Wednesday, 7 October 2020

DA-2019/247 Engineering Referral Comments

CLUB WILLOUGHBY
26 CRABBES AVENUE
NORTH WILLOUGHBY

Figure 1 – Model Layout

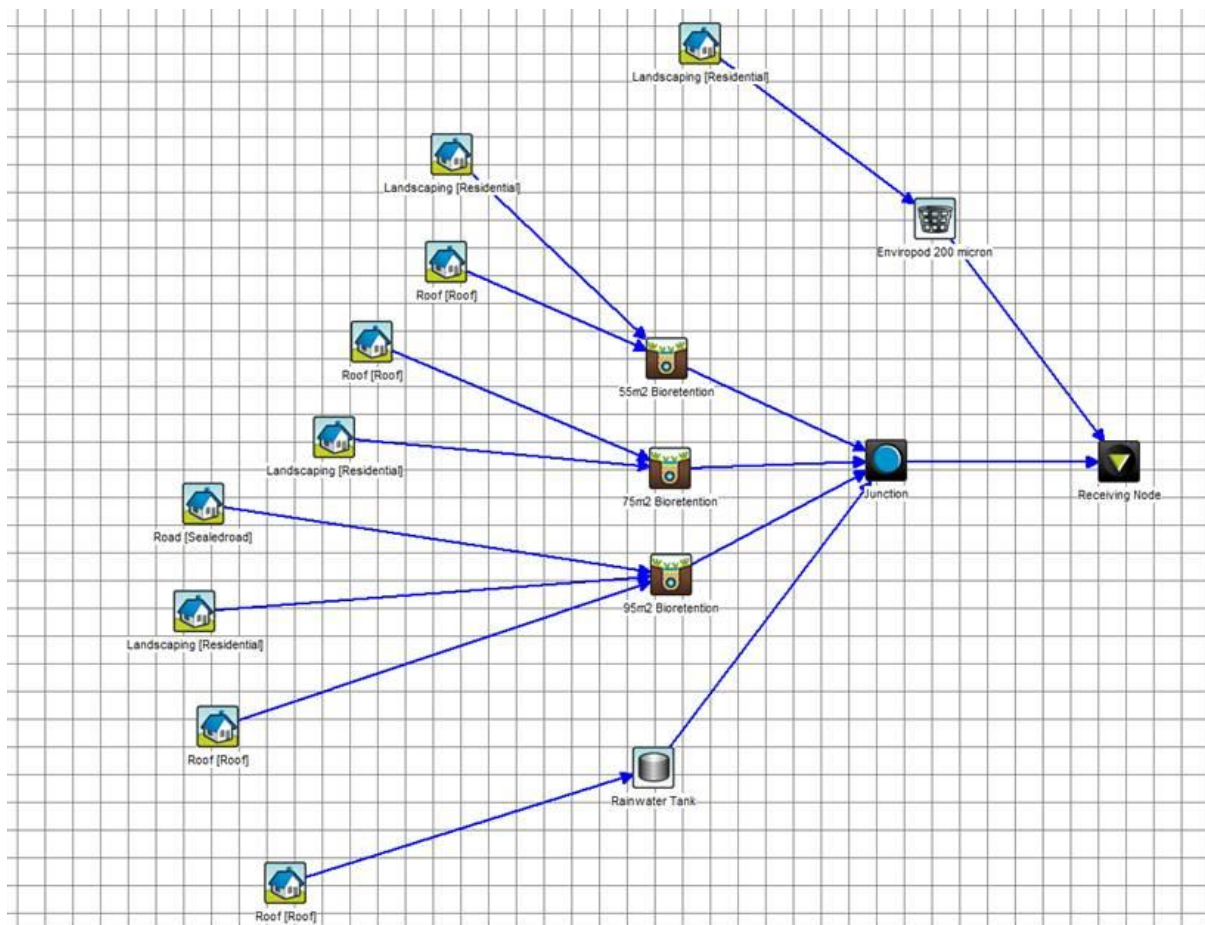
A summary of the MUSIC analysis is required. Council is not able to use the model provided, and we require:

- *The model layout*

See below for the updated model layout

Figure 2 – Model Results

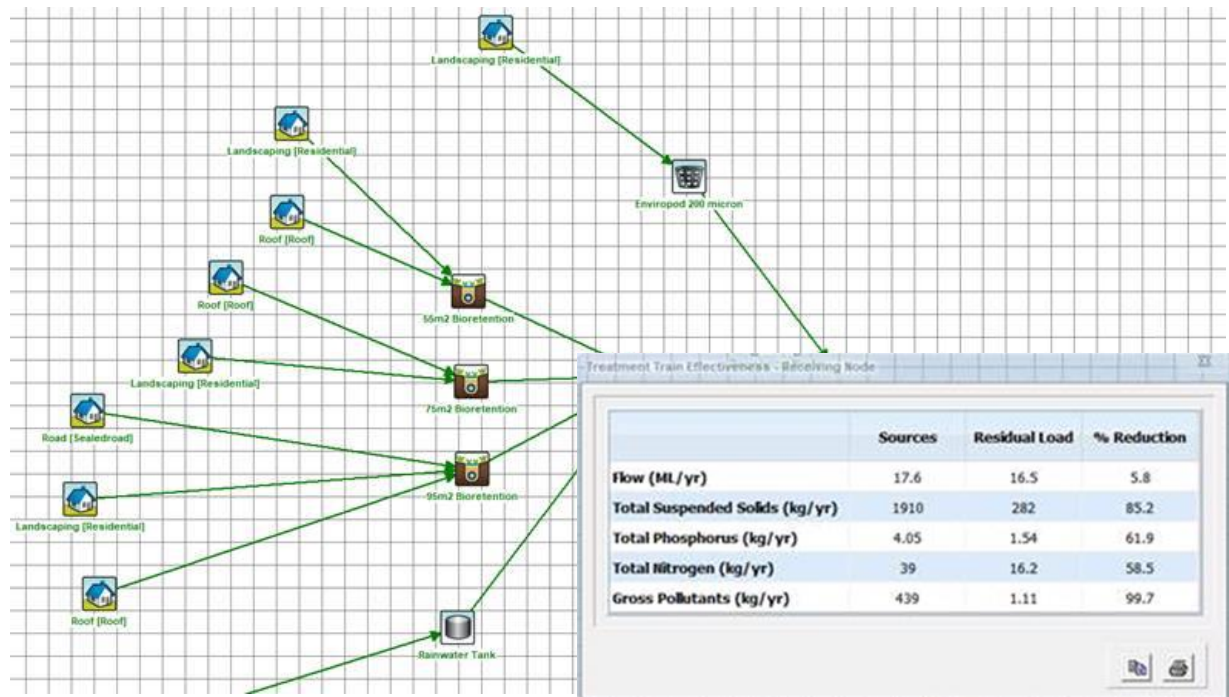
- *A summary of the results*

See below for a copy of the results output table

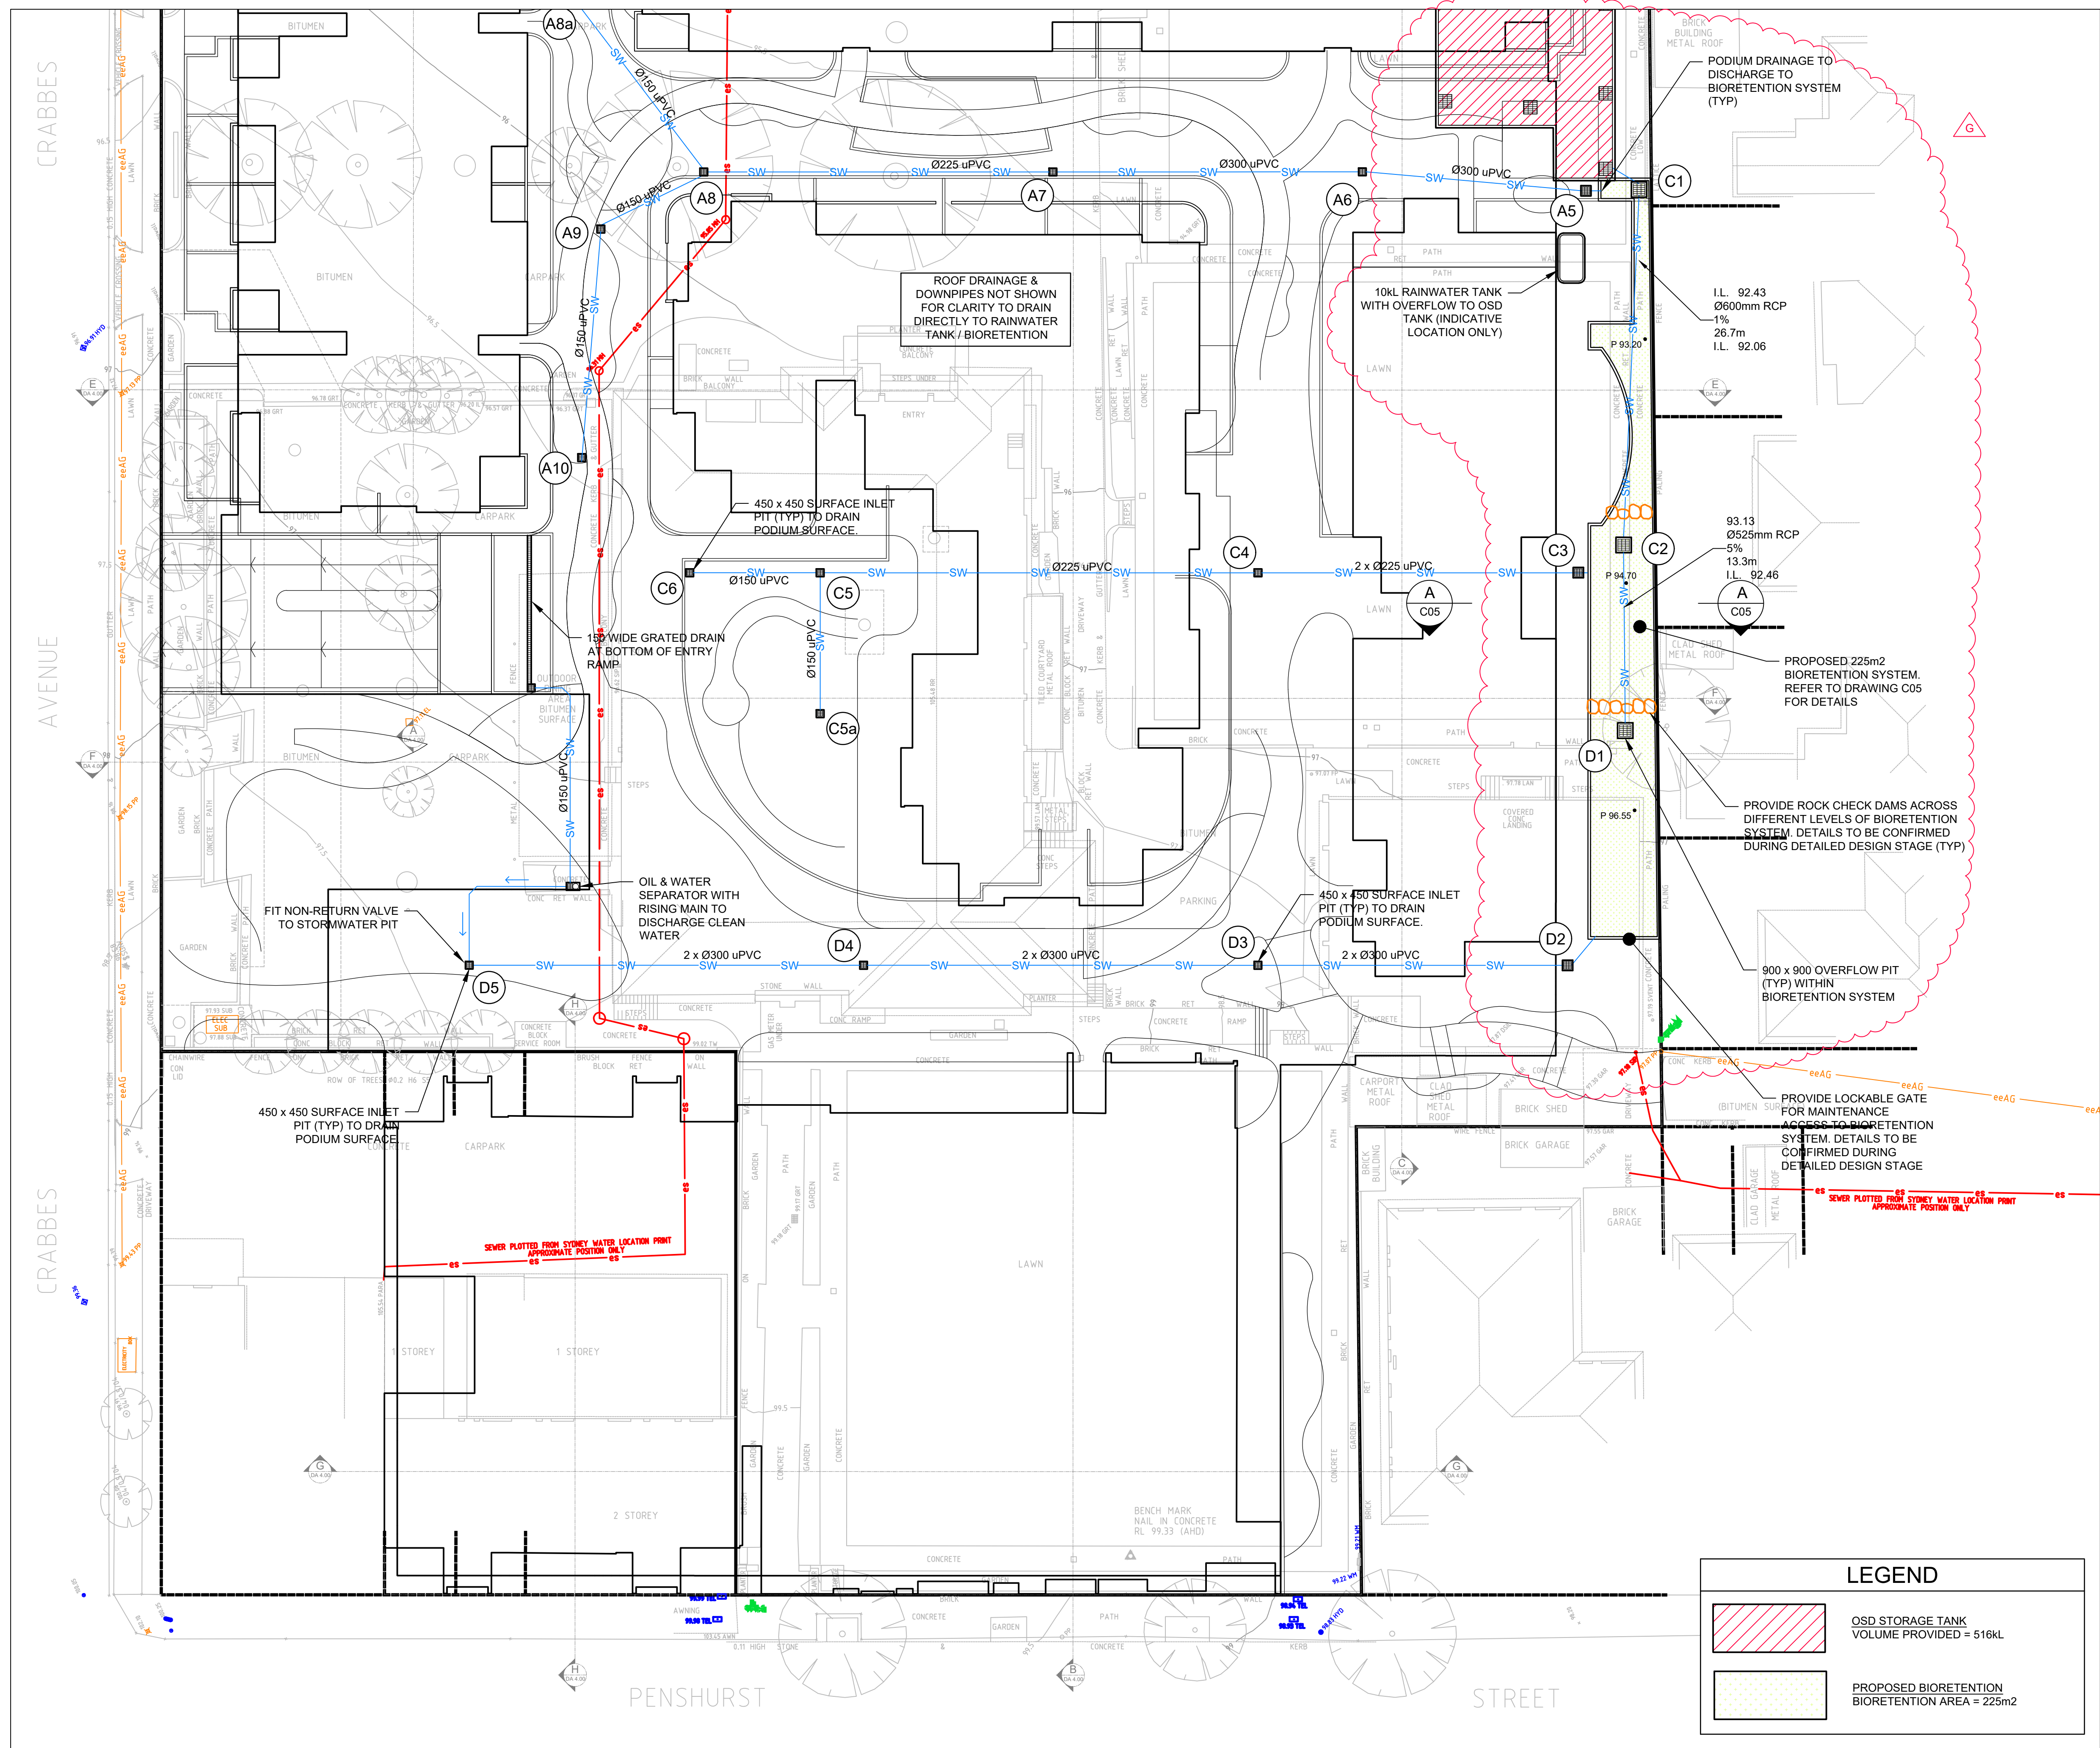
- *Details of the treatment rate assumed for the enviropod inserts*

The removal rates adopted for the enviropod were based on manufacturers specifications as follows with a treatable flow rate of 20L/s:

- TSS = 54%
- TP = 30%
- TN = 21%
- GP = 95%
